**Addendum**  
**Environmental Impact Study**  
**Cielos de TARAPACÁ**

**Valhalla Energy**

**July 2015**

Figure 19: Project Paths

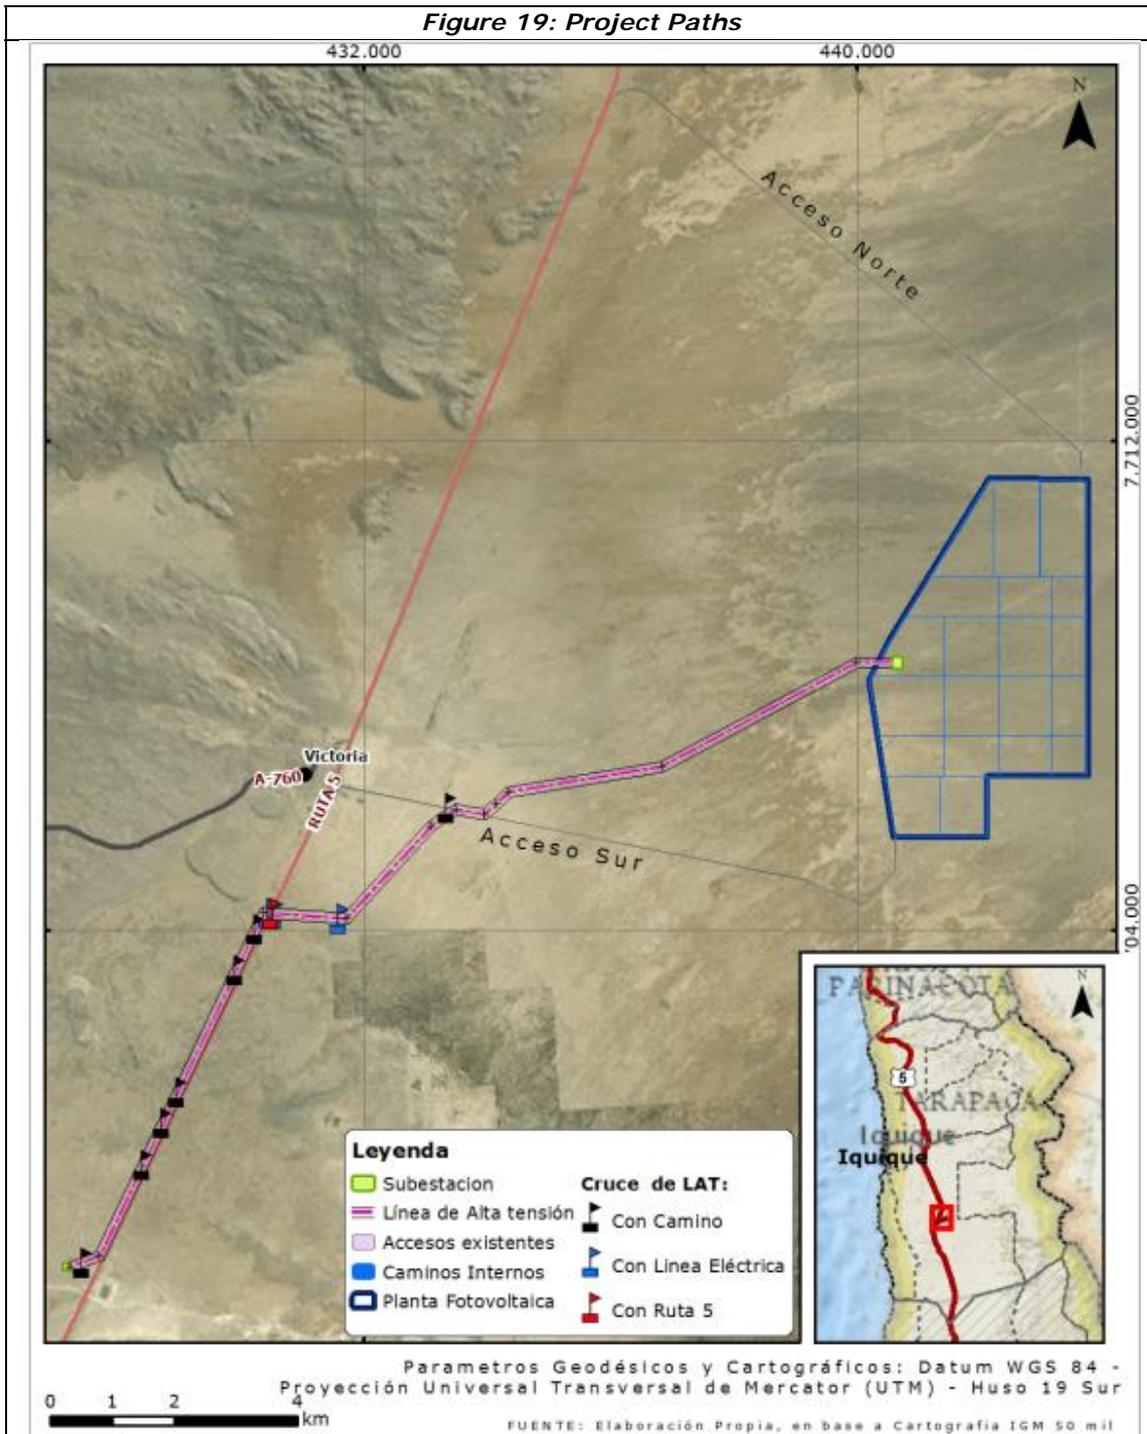
c) To present evaluation of the possible impacts for the human environment of the activity "*Construction and improvement of access roads*" Stage of construction, since during the execution of these works will be carried out works to less than 100 meters of the locality of Victoria, corresponding to the South access of the project that is born in this locality, estimating the vehicular flow, type of vehicles to use, Measures on the issue of material Particulate From this dirt road, and the emission of noise at the point of connection with Route 5 describing also the circulation by the populated sectors of Victoria. In this sense, you must provide all the antecedents to verify that no risk will be generated to the health of the population and/or their life systems.

With respect to the locality of Colonia of painted, it is indicated that this one will not be affected by the vehicular flow, since the income of the project is produced by Route 5, where there is a direct access to it. The access routes to the painted colony can be seen in the following Figure.
